VENTURA WATER SUPPLY PROJECTS

Final Environmental Impact Report
CASE NO. EIR-9-19-52130
PROJECT# PROJ-1383313707
SCH No. 2017111004

September 2019

Figure 1: Potential groundwater dependent ecosystems within the Oxnard Basin and the proposed Project areas.

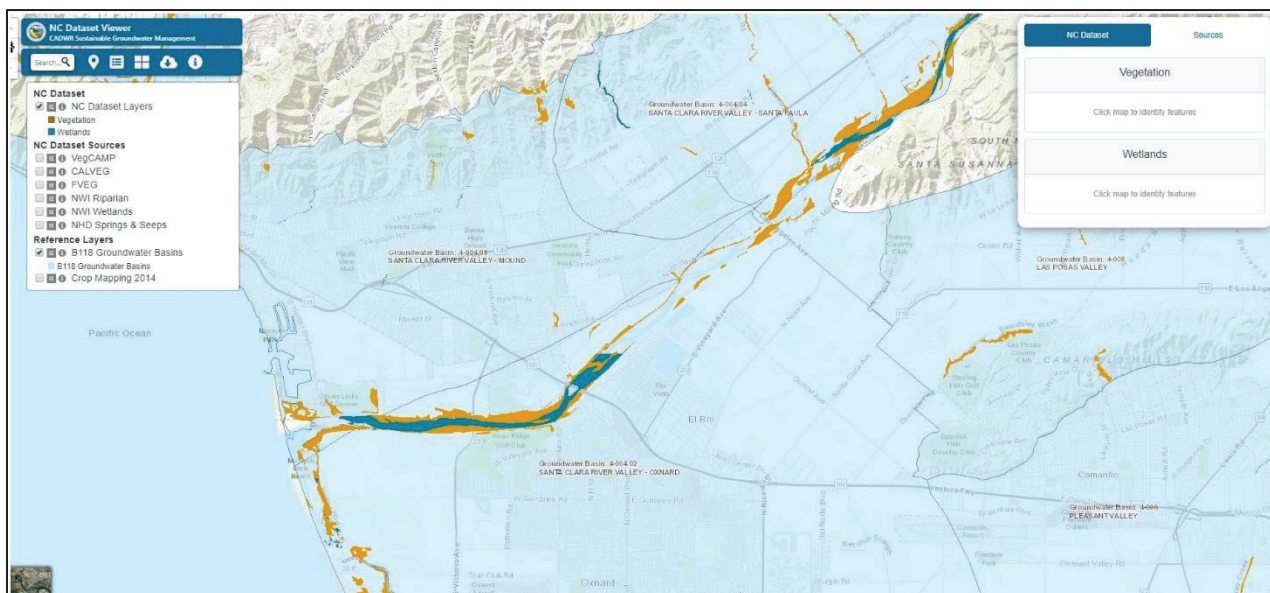
Why impact would occur: The Department of Water Resources (DWR)'s Natural Communities Commonly Associated with Groundwater Dataset identifies many potential GDEs in the Project's geographic scope (DWR 2019). The potential GDEs identified in orange in Figure 1 of DWR's dataset likely consists of phreatophytic vegetation, which rely on water supply from the groundwater table.

Mitigation Measure #1: The final EIR should verify the existence of GDE that could be affected by the Project and identify vegetation communities (e.g., species compositions, structural diversity, and integrity) and associated rooting depths/optimal groundwater table elevations. This will allow Project proponents to: 1) determine which proposed phase or alternative is most likely to impact GDEs based on basin hydrology; 2) deploy representative groundwater monitoring stations within GDEs to track groundwater levels and vegetation responses over time; and, 3) establish thresholds/triggers for adaptive management to respond to stressed vegetation as needed. If the Project is expected to result in habitat benefits to GDE's, monitoring should be utilized to track and confirm positive and negative outcomes.

Figure 10-2
1978 Aerial Photograph of the Proposed Treatment Wetlands and Harbor Blvd Sites

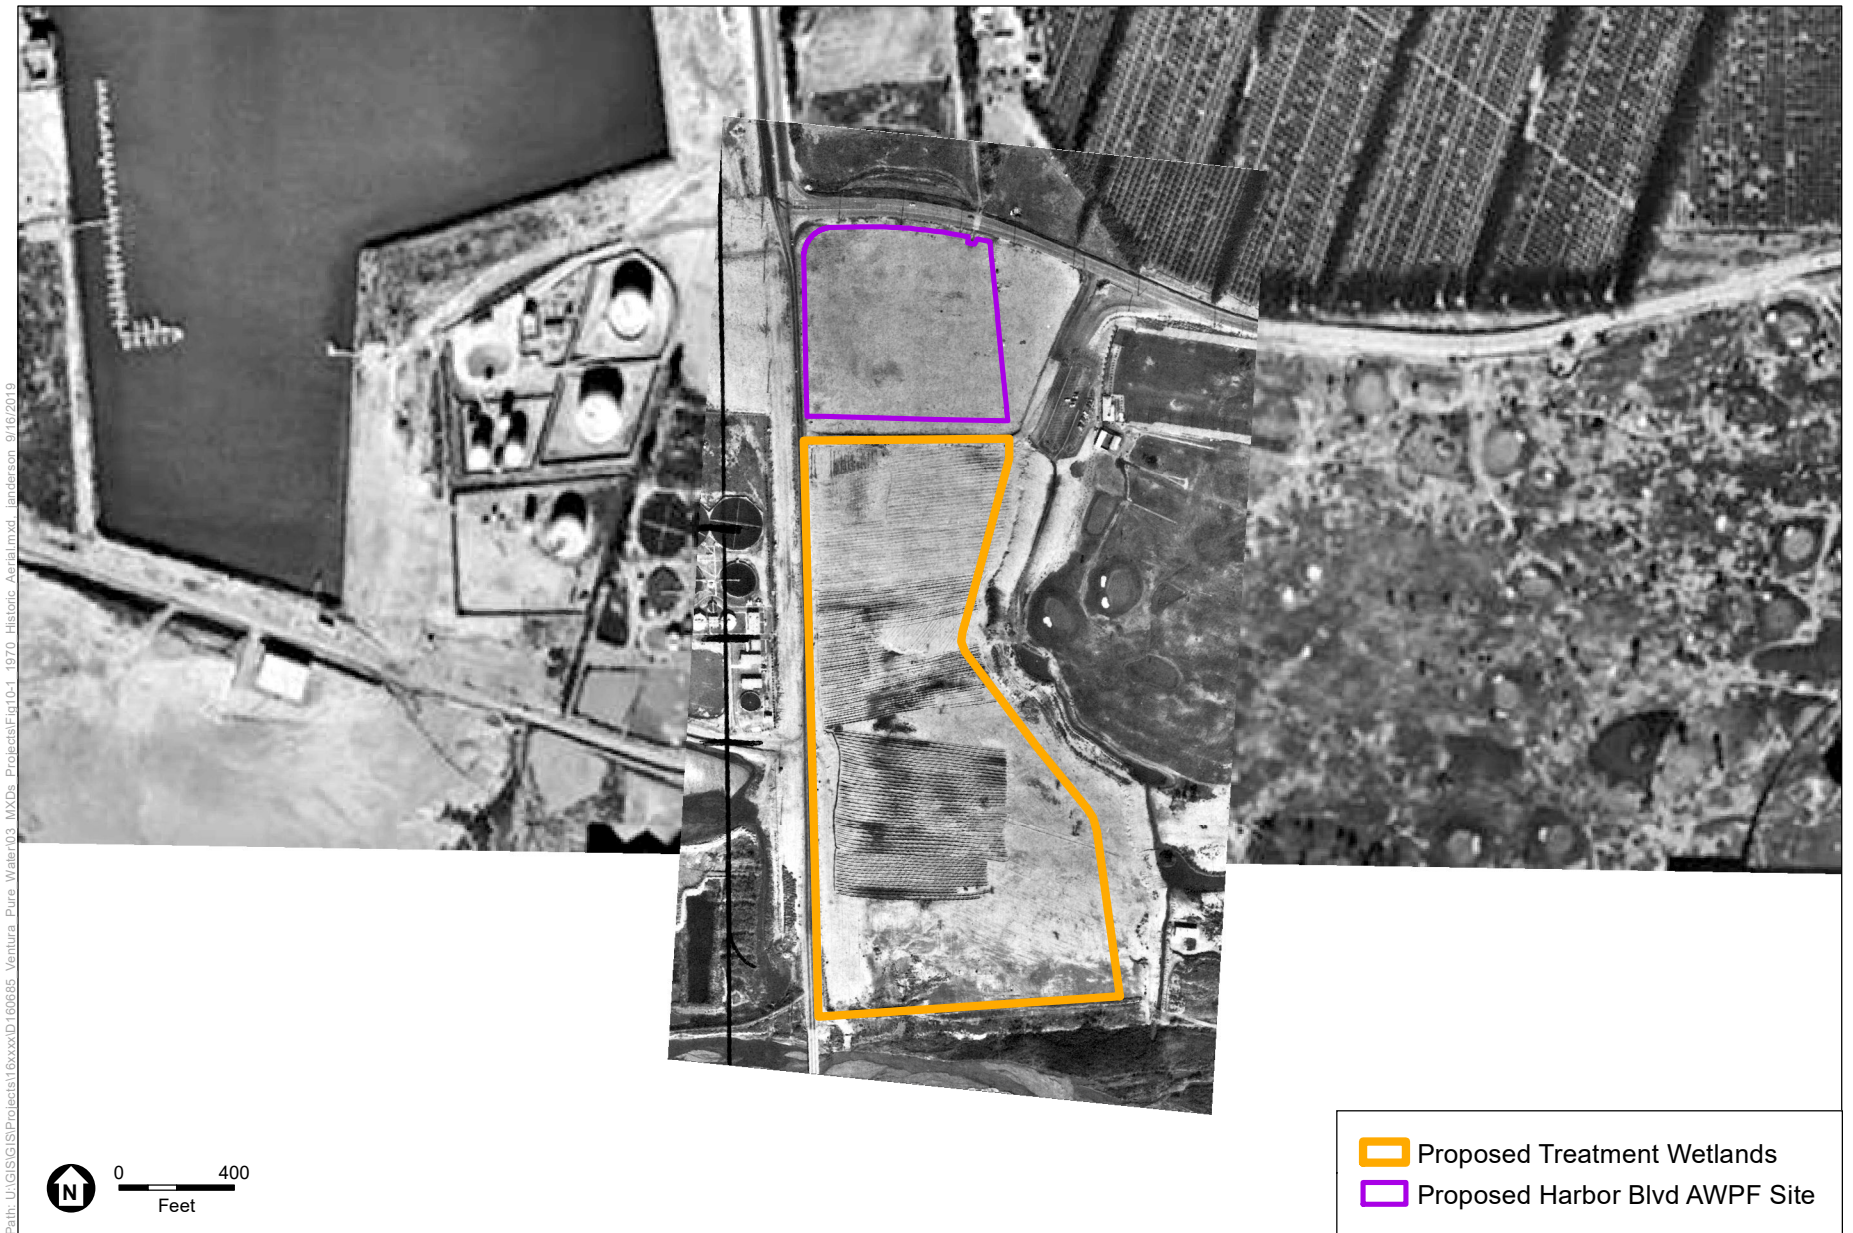
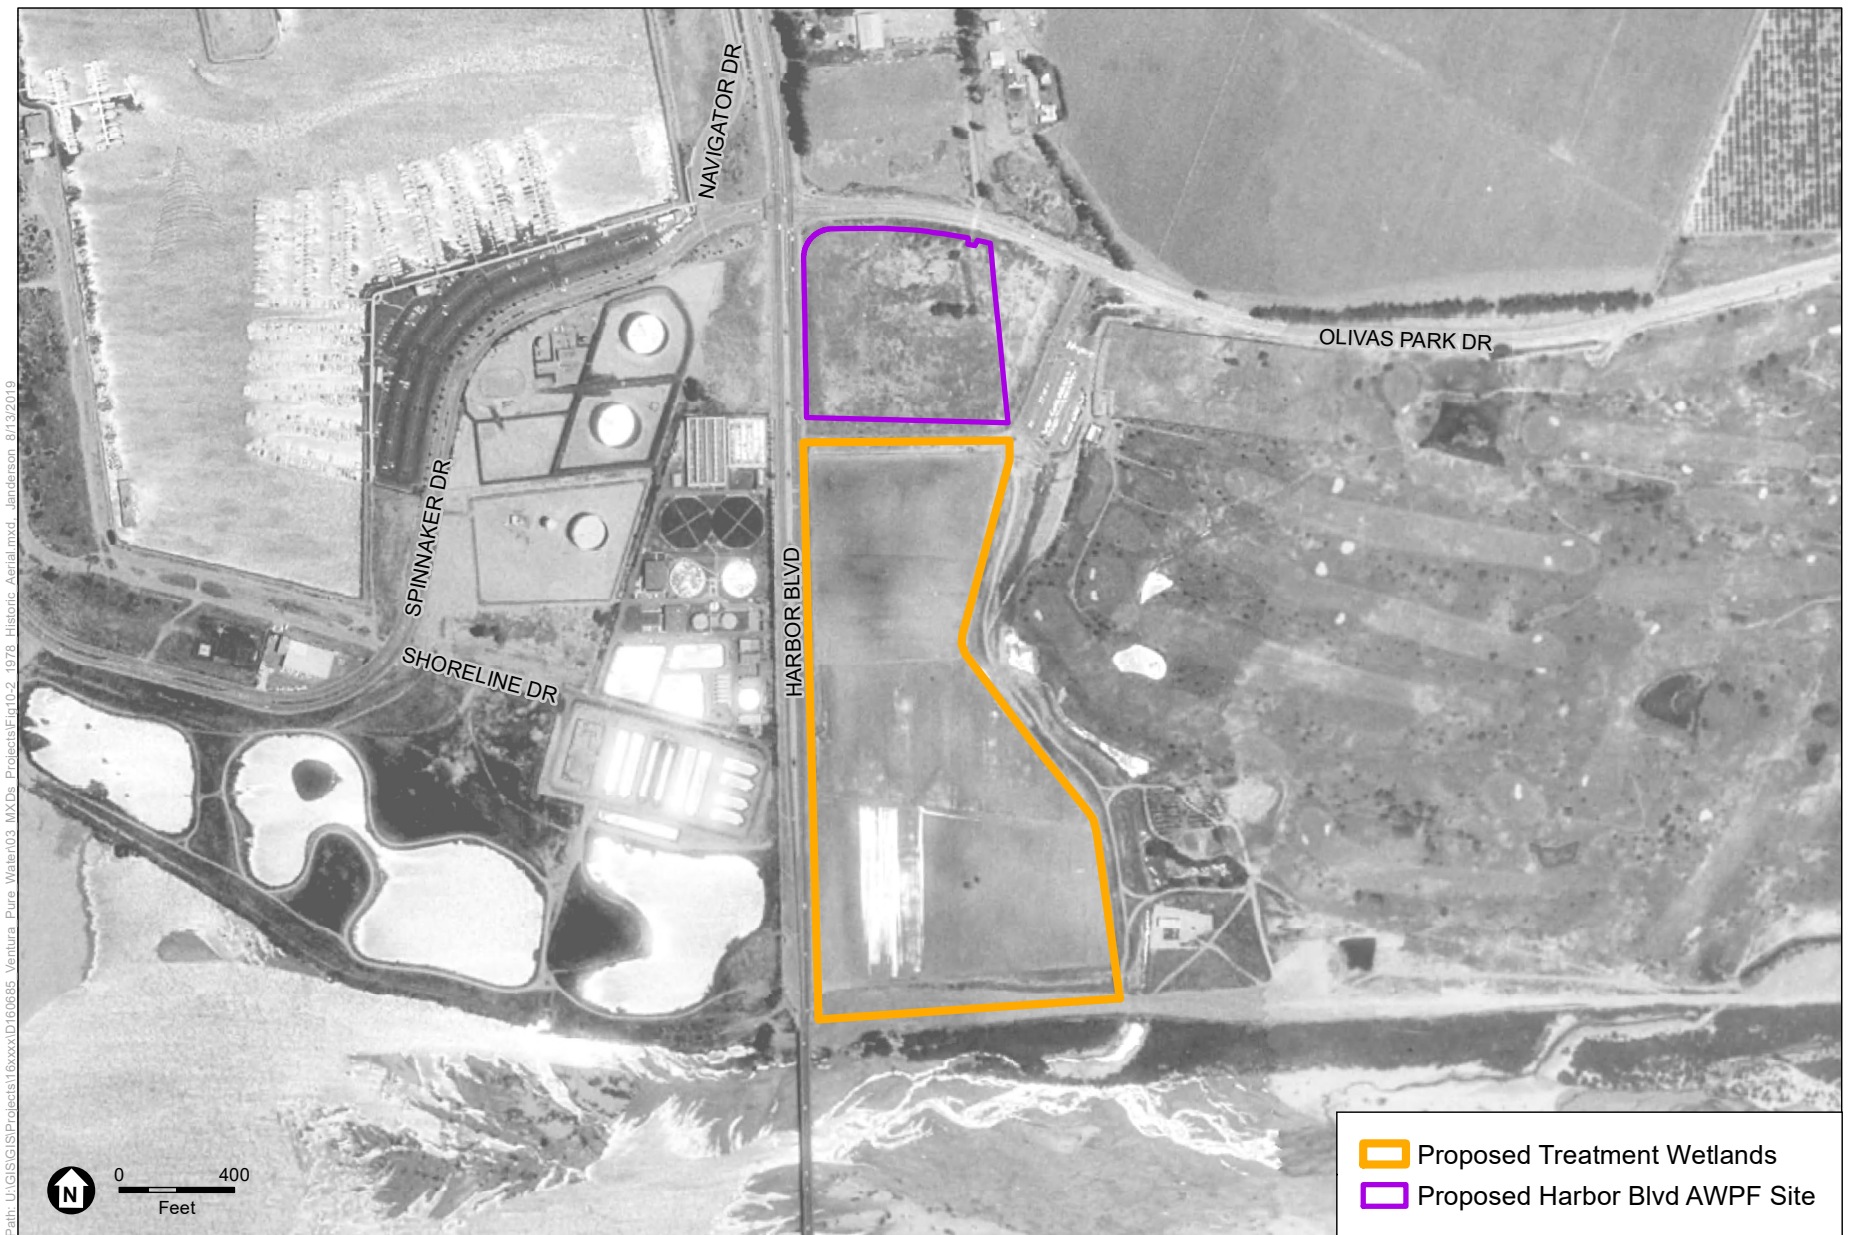
The comment discusses potential historical and currently sensitive habitat types that may have existed in the past (constituting a historical "ESHA" or "environmentally sensitive habitat area"), or that may now exist on the Harbor Boulevard AWPF site and on the Harbor Boulevard Treatment Wetlands Site.

With respect to the potential for the presence of historical ESHAs on the AWPf and Treatment Wetlands Site, both of which are in the Coastal Zone, the City reviewed several aerial photographs of the Harbor Boulevard AWPf site and, in addition, of the Treatment Wetlands Site (which is located in close proximity to the AWPf site). It also consulted with CCC staff regarding prior development applications for the site. The City reviewed photographs to document the condition of these parcels from 1977, at the time the California Coastal Act was enacted. **Figure 10-1** shows that prior to 1970 the two sites were used as deposition areas for sandy material, an activity that left both sites completely devoid of vegetation, prior to the enactment of the Coastal Act. However, subsequent to the deposition activities, and following 1977, some habitat began to emerge on both sites. As shown in **Figure 10-2**, a small area of vegetation had emerged by 1978 on the Harbor Boulevard AWPf site.

Records from CCC proceedings indicate that a prior application for development on the Harbor Boulevard AWPf site¹ recorded that some arroyo willow vegetation was present on the site in 1999. As noted in Figure 10-1, it appears that fill material was indeed placed on the site sometime prior to 1970, 7 years before the Coastal Act was enacted. Replacement of habitat value would not be required for any ESHA eradicated by fill before 1977, but would be required for ESHA that was not eradicated or that developed subsequent to 1977. Arroyo willow vegetation was documented on the Harbor Boulevard AWPf site in 1999.² The vegetation has since been removed. To ensure consistency with the Coastal Act and LCP, compensation for this eradicated, historical ESHA may be necessary.

Figure 2-2
Phase I Project Components

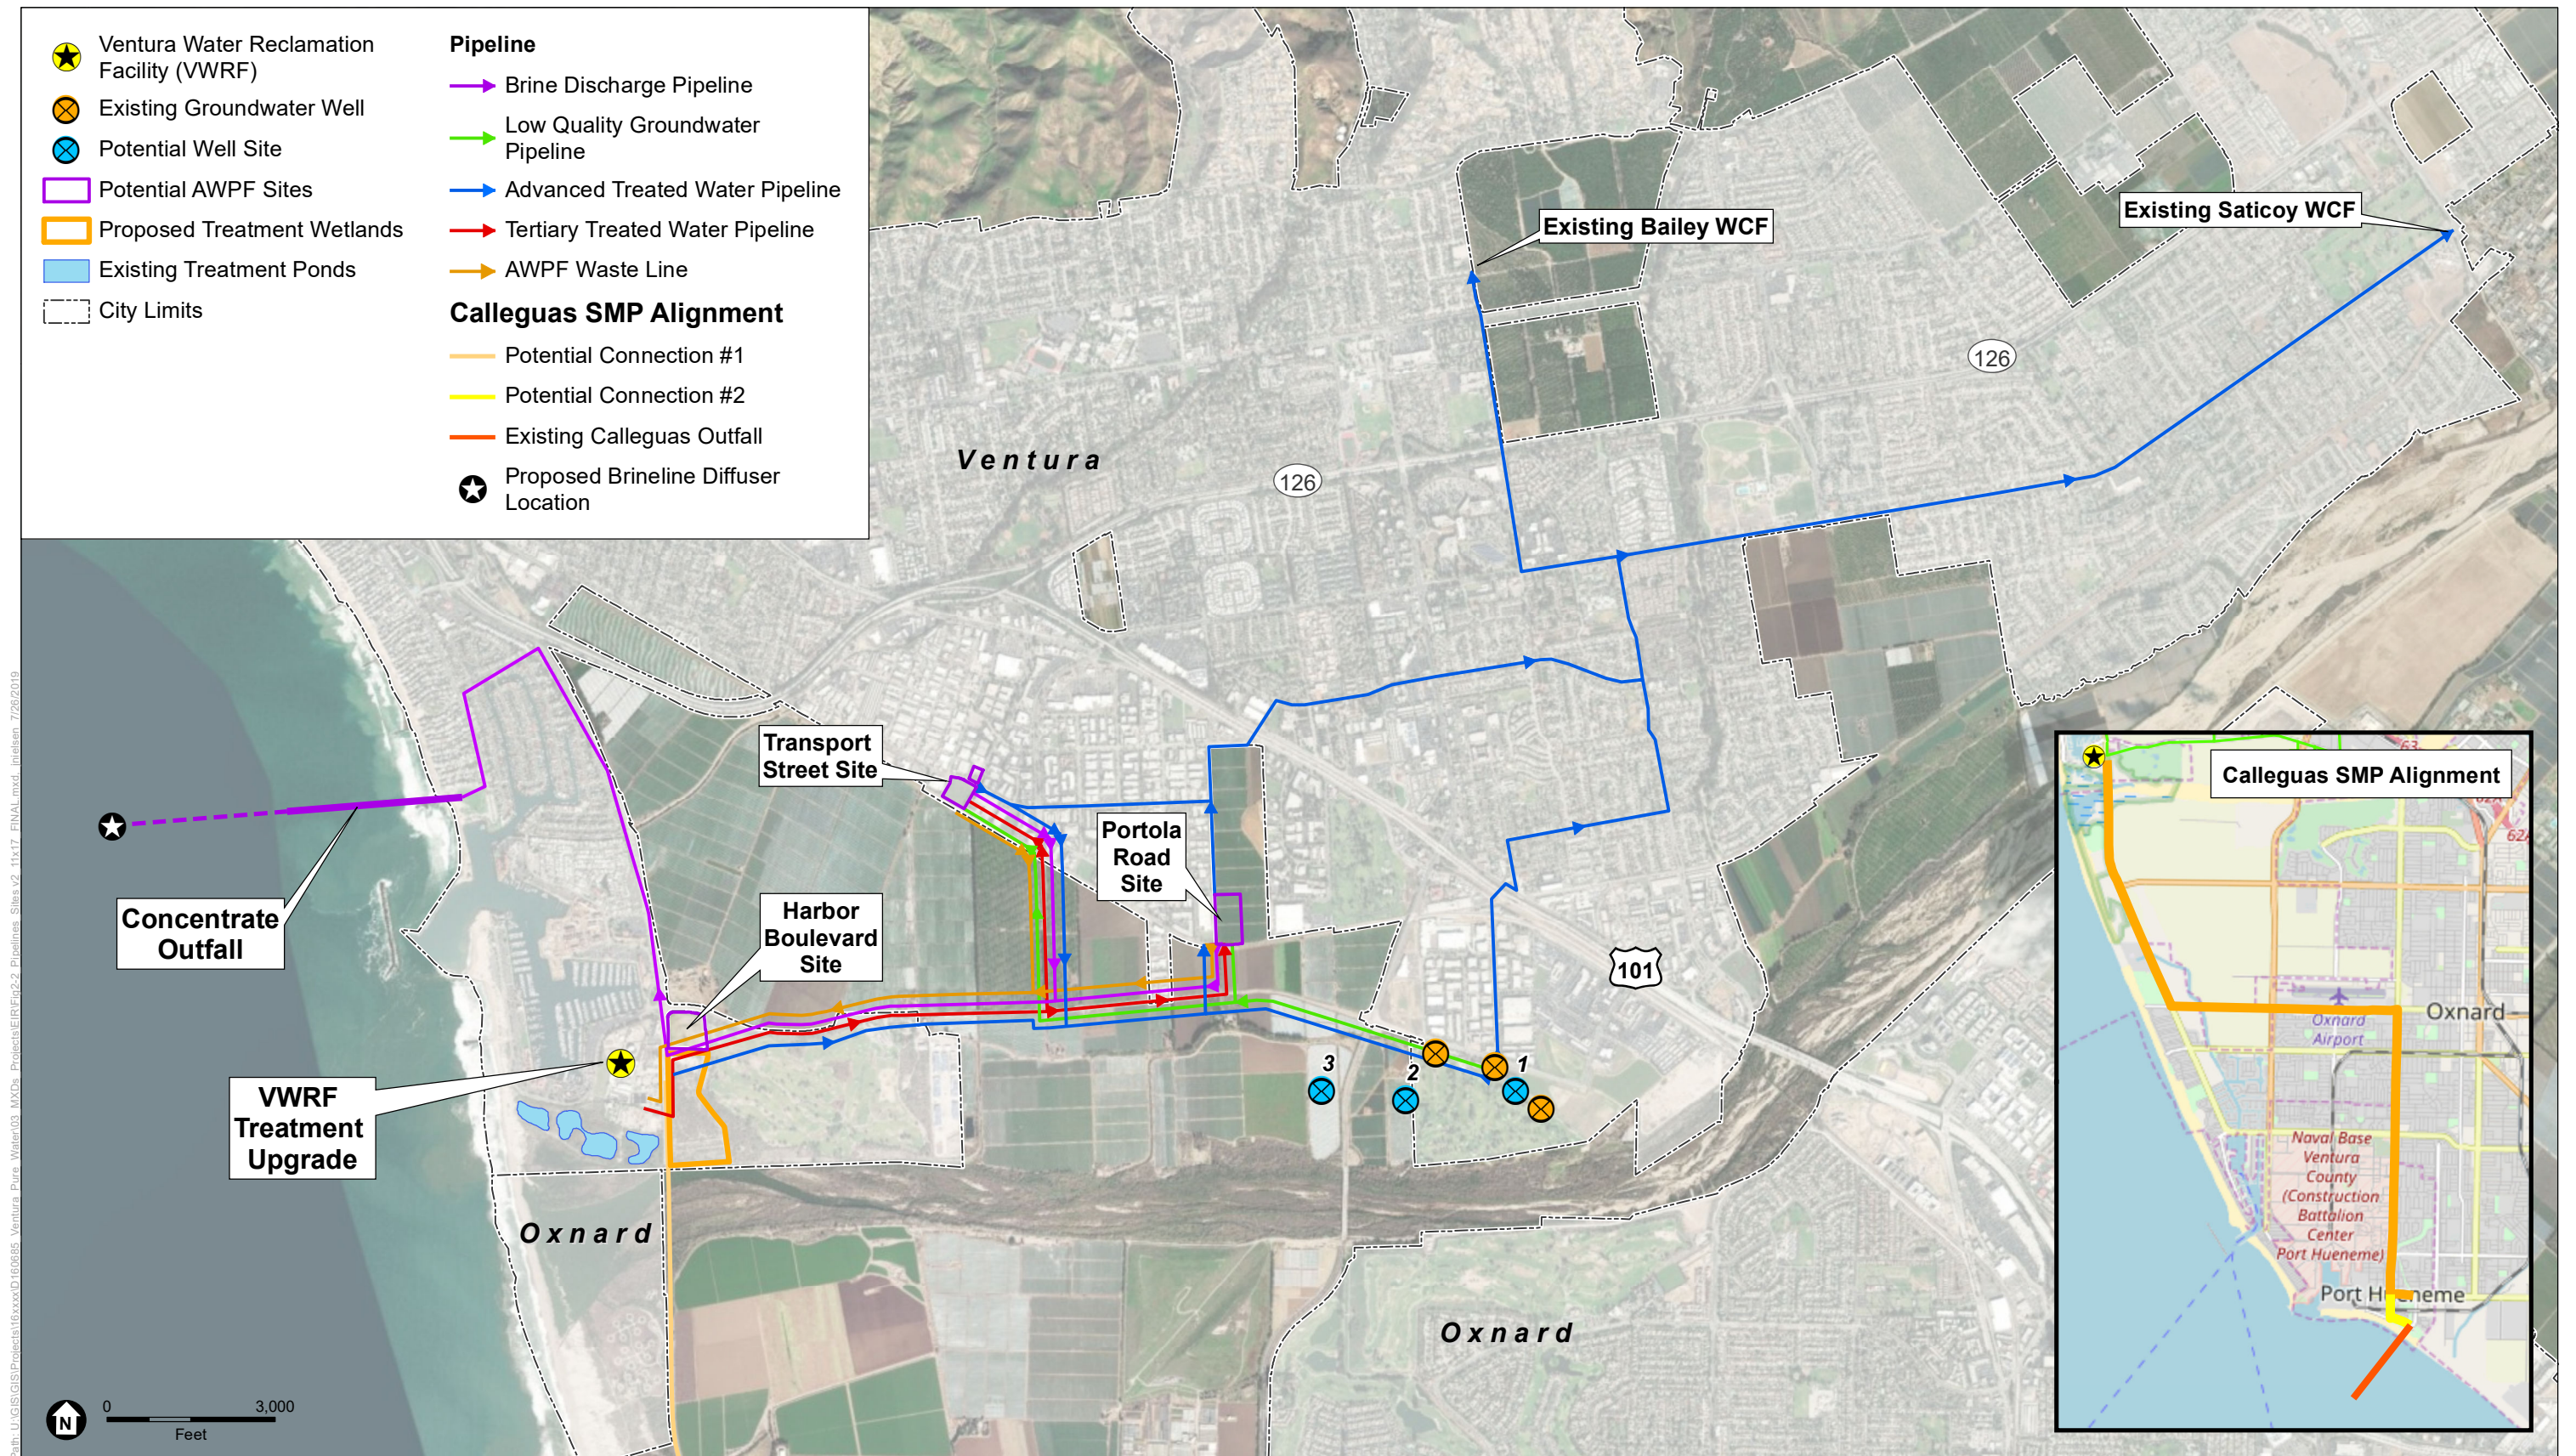
Commission staff again request, from the December 1, 2017 comment letter, to have the EIR provide additional details of, and maps showing, the Calleguas Municipal Water District's existing SMP ocean outfall. Figure 2-2 only shows the proposed onshore pipeline connection to the Calleguas SMP, and does not show the location of the SMP outfall.

In response to the comment, Figure 2-2 has been modified to show the location of the existing SMP outfall. No modifications to the outfall would be required and, as discussed in Response S5-9, the brine contribution would need to be incorporated into the existing or renewed NPDES permits, but is not expected to exceed existing NPDES permit effluent limitations applicable to the existing outfall.

Figure 2-2 Figure 2-2 has been modified to show the location of the existing SMP outfall.
